Addenda No. 1

SUBJECT: US101 & OR38: Reedsport to Winchester Bay Paving
Oregon Coast Highway
Douglas County
Grading, Paving & Sidewalks Project
(Bids to be opened and read February 26, 2009)

The following changes are made to the Project Bid Booklet:

SHEET NO. 2A-3

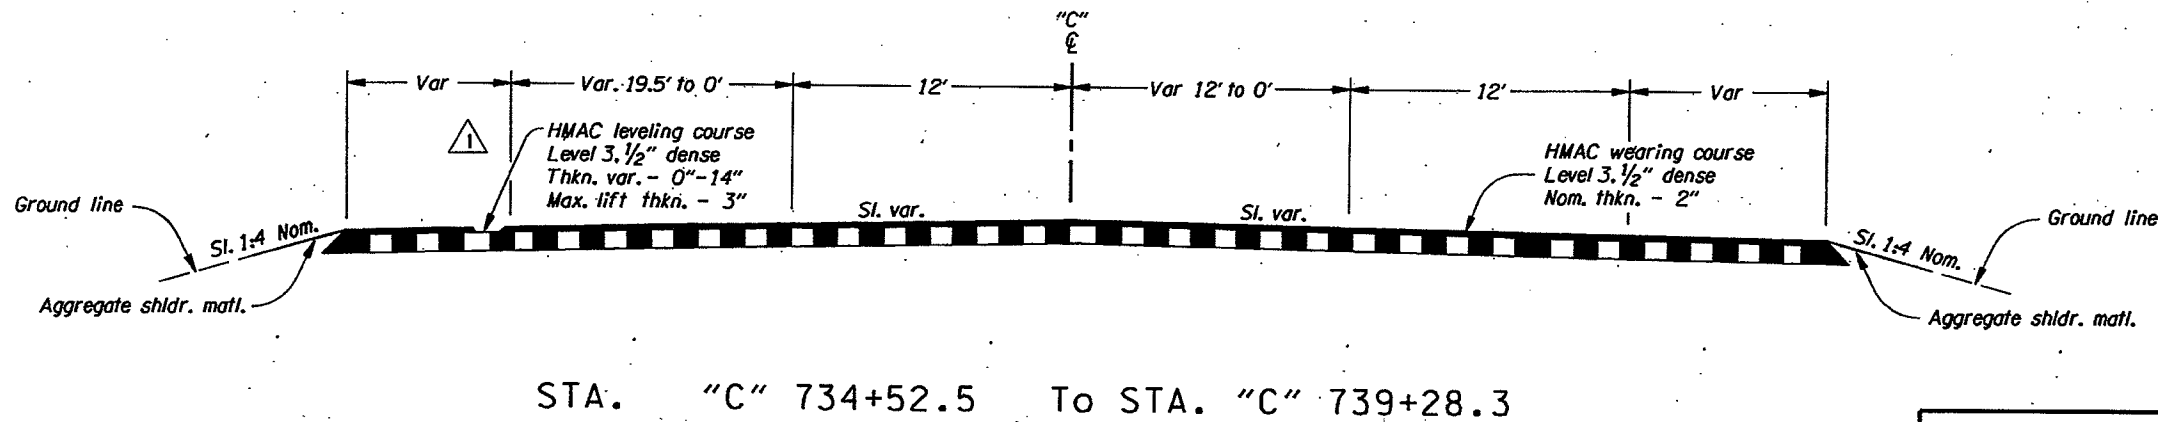
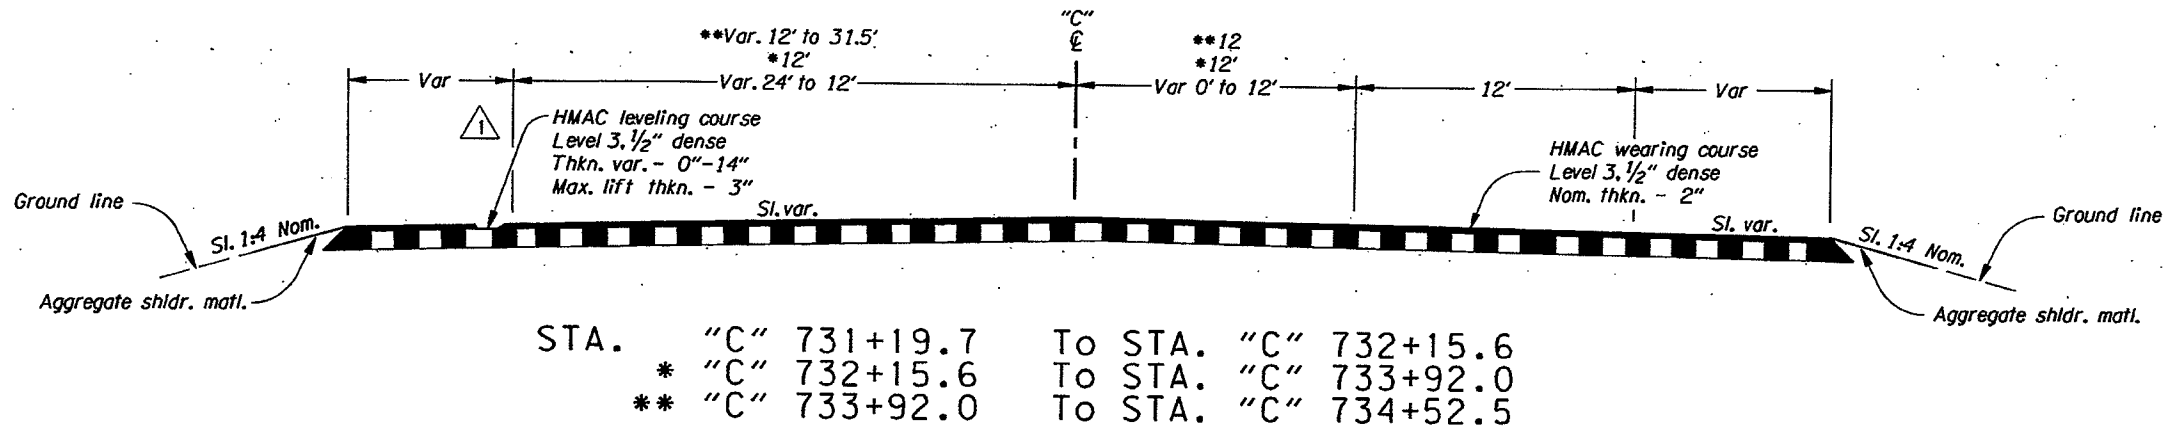
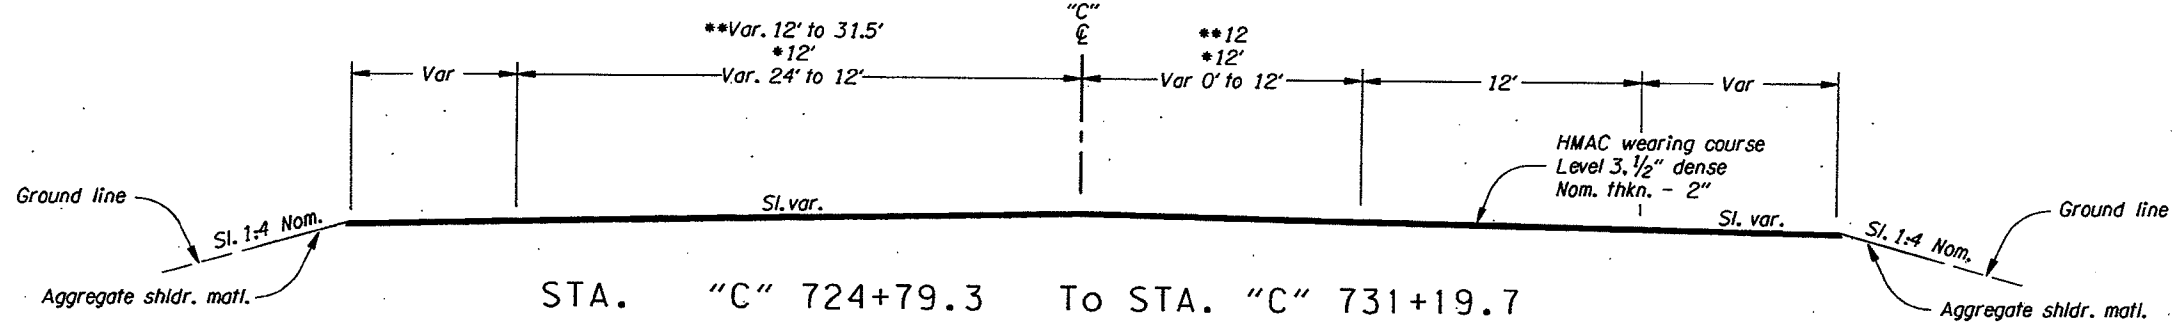
Rev. No.	Description	Date	Engineer
1	Insert pavement thickness	2-10-09

SHEET NO. 2A-4

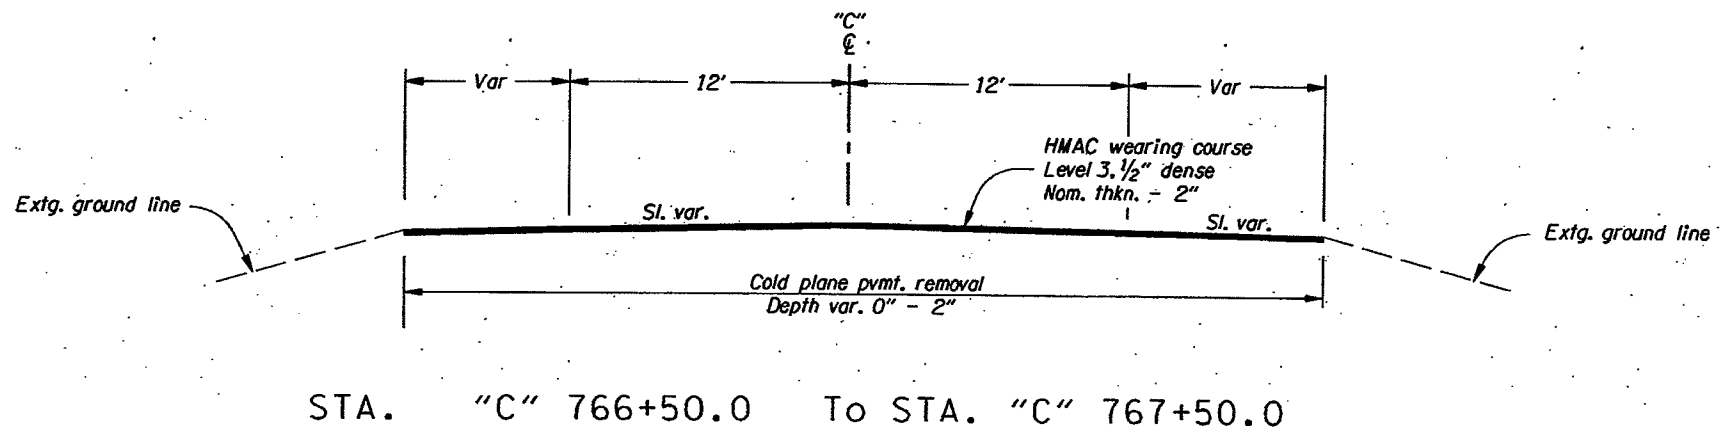
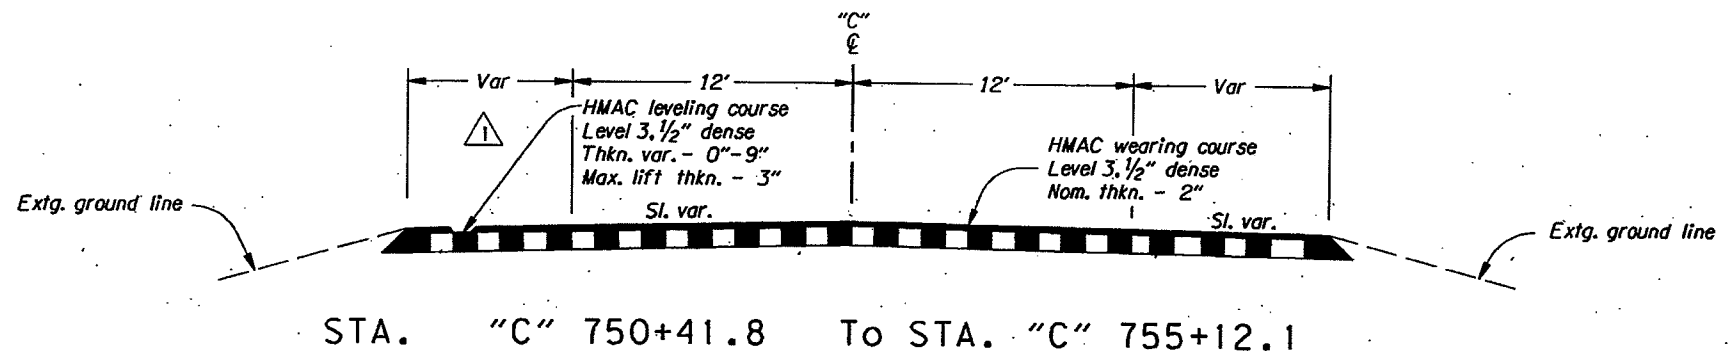
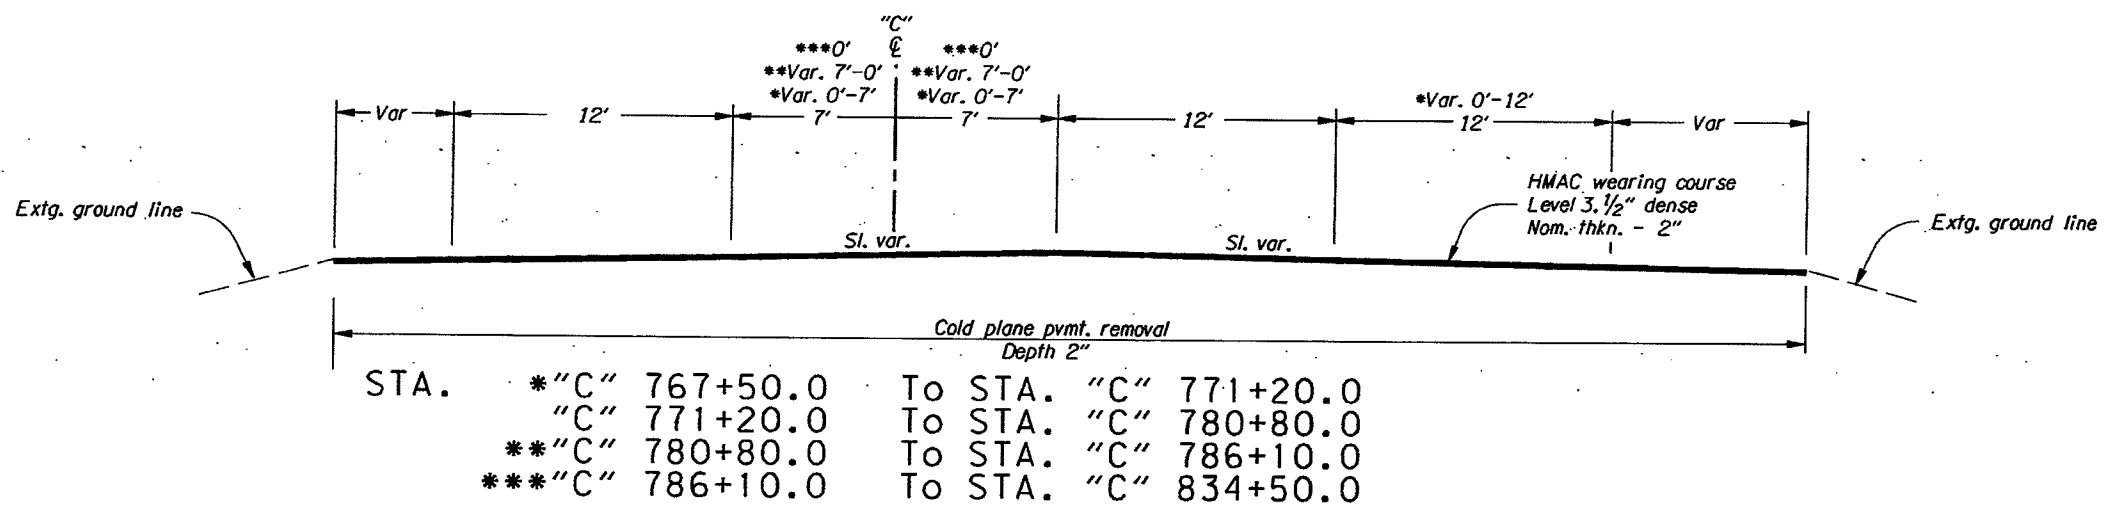
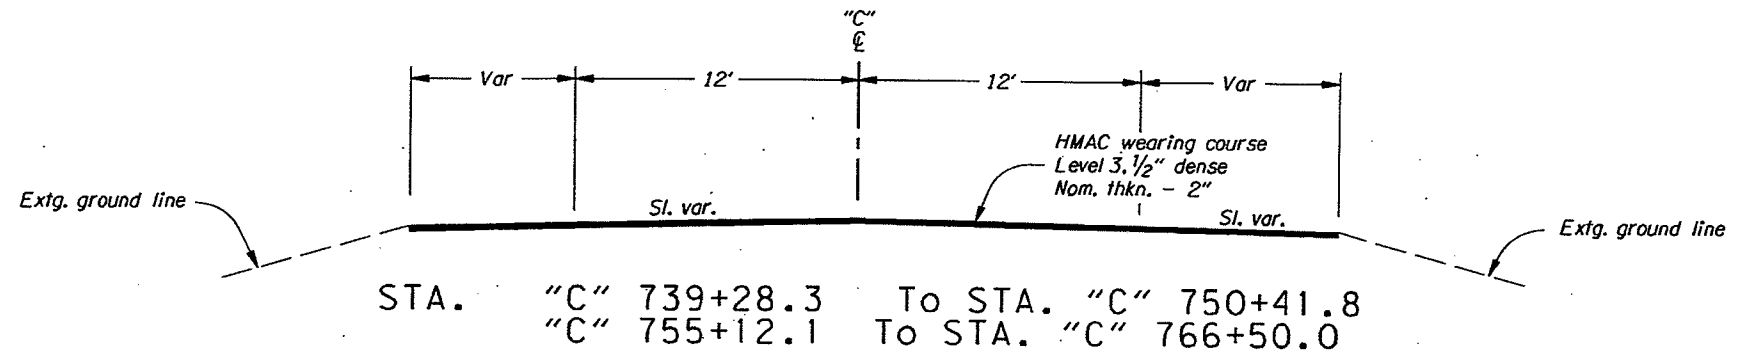
Rev. No.	Description	Date	Engineer
1	Insert pavement thickness	2-10-09

SHEET NO. **2B**

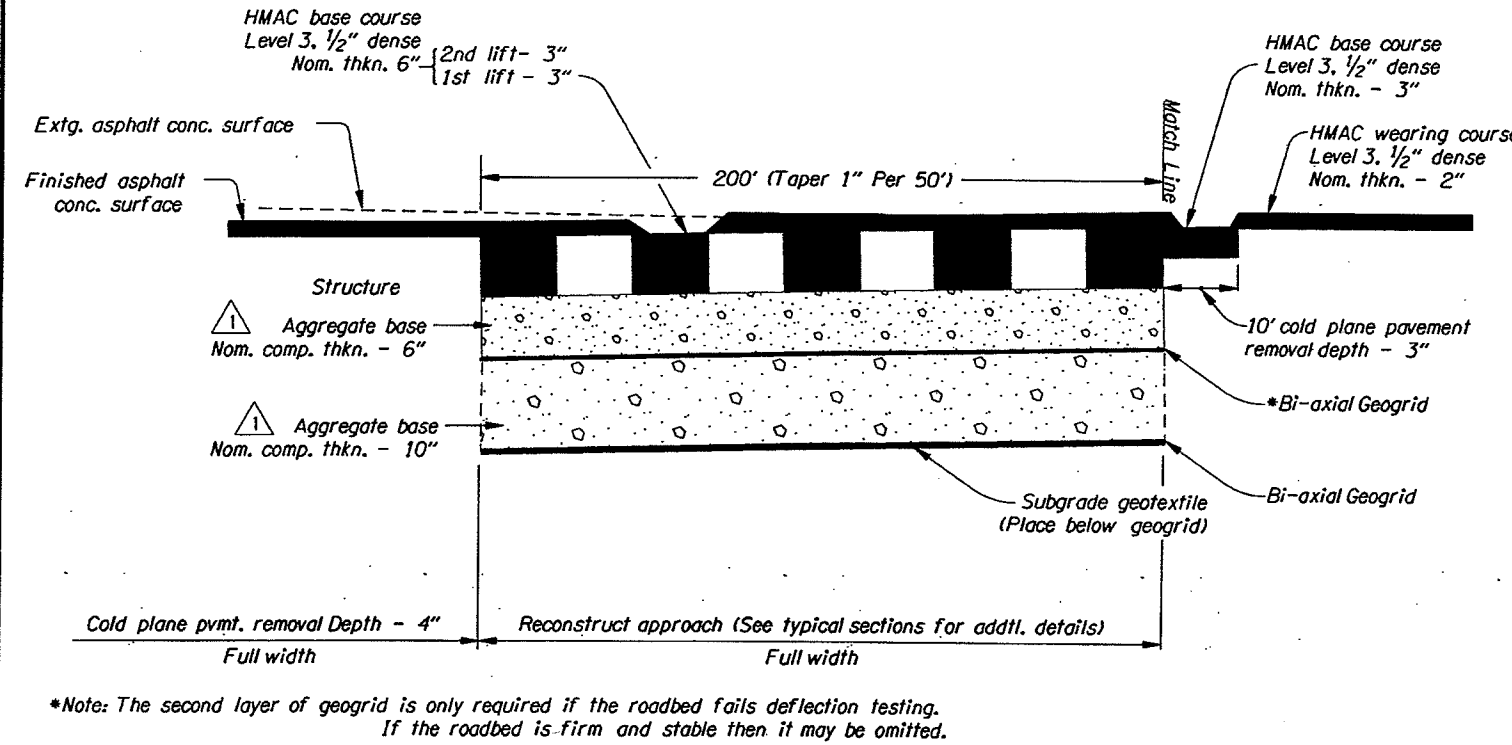
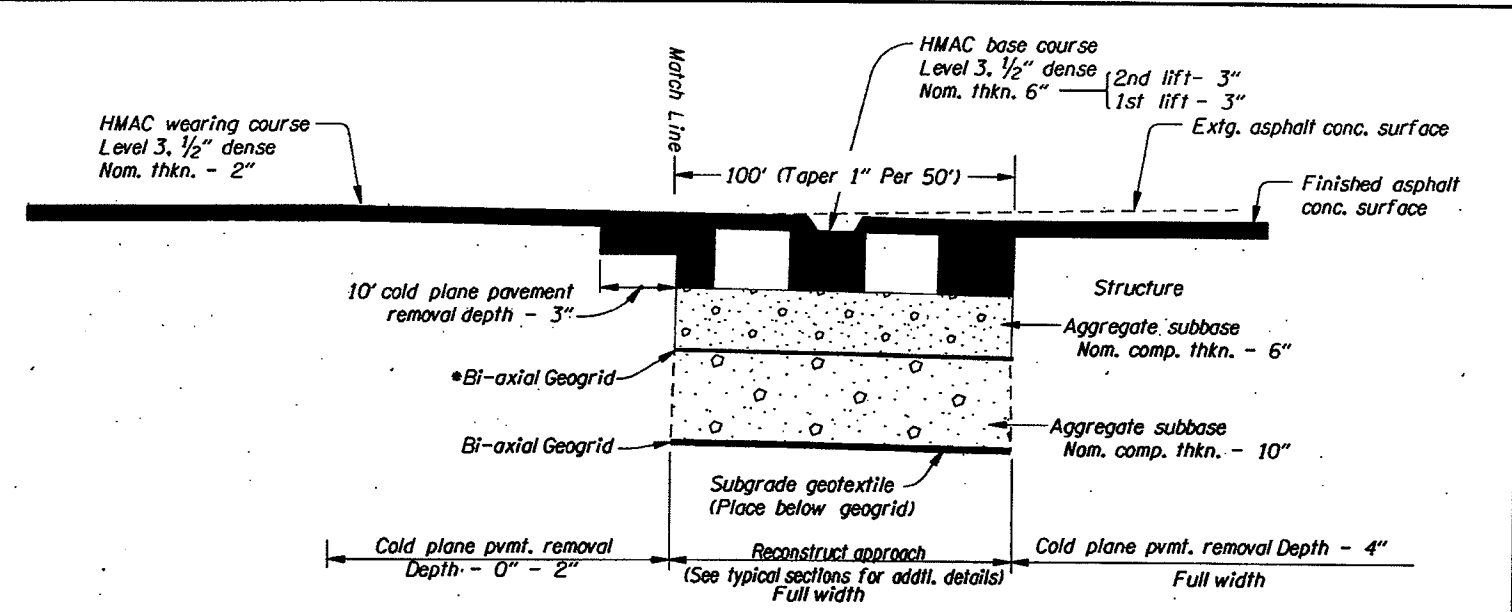
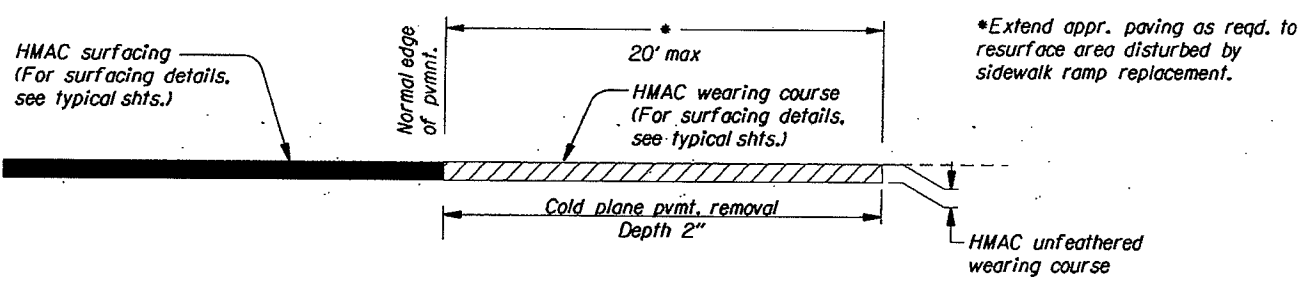
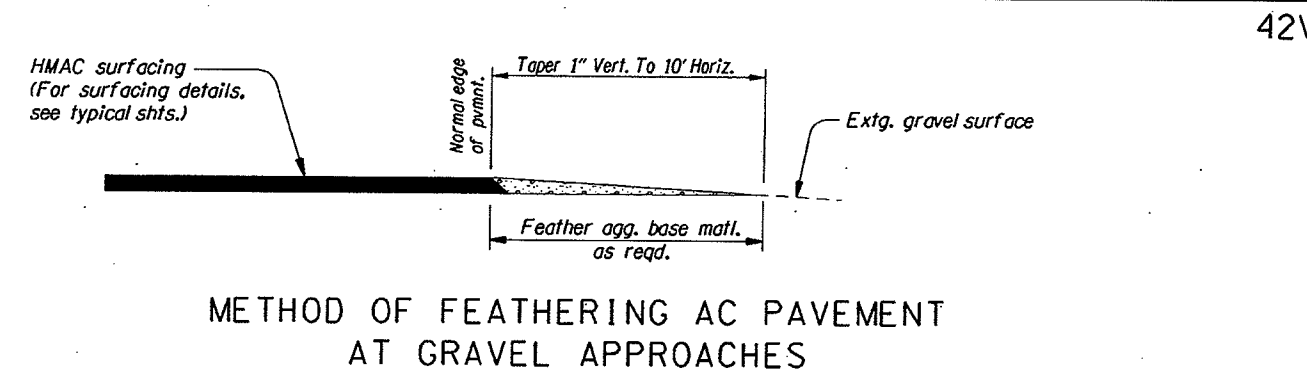
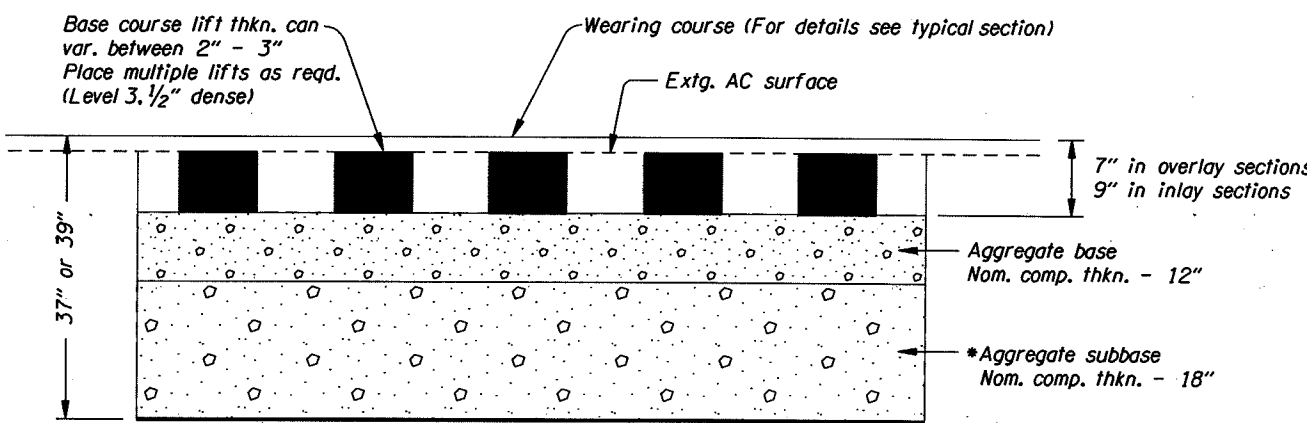
Rev. No.	Description	Date	Engineer
1	Changed to aggregate base	2-10-09

GUARDRAIL/AC PAVEMENT DETAIL

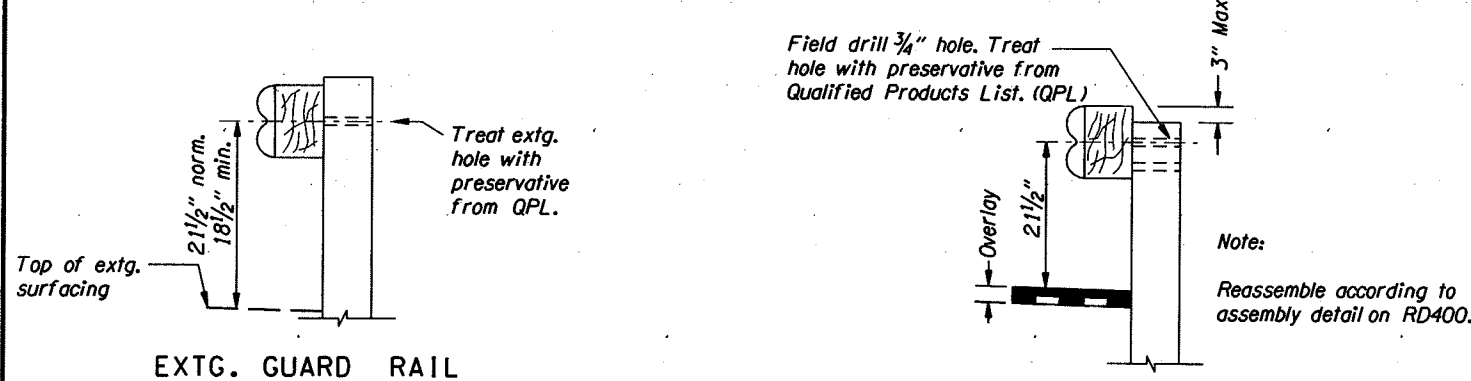
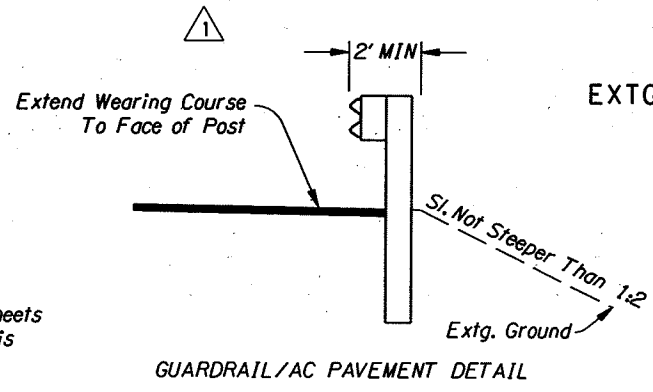
Rev. No.	Description	Date	Engineer
1	Added guardrail detail		B
2	Note addition/revision		B

Use only if existing guard rail meets current guard rail standards or is modified to do so.
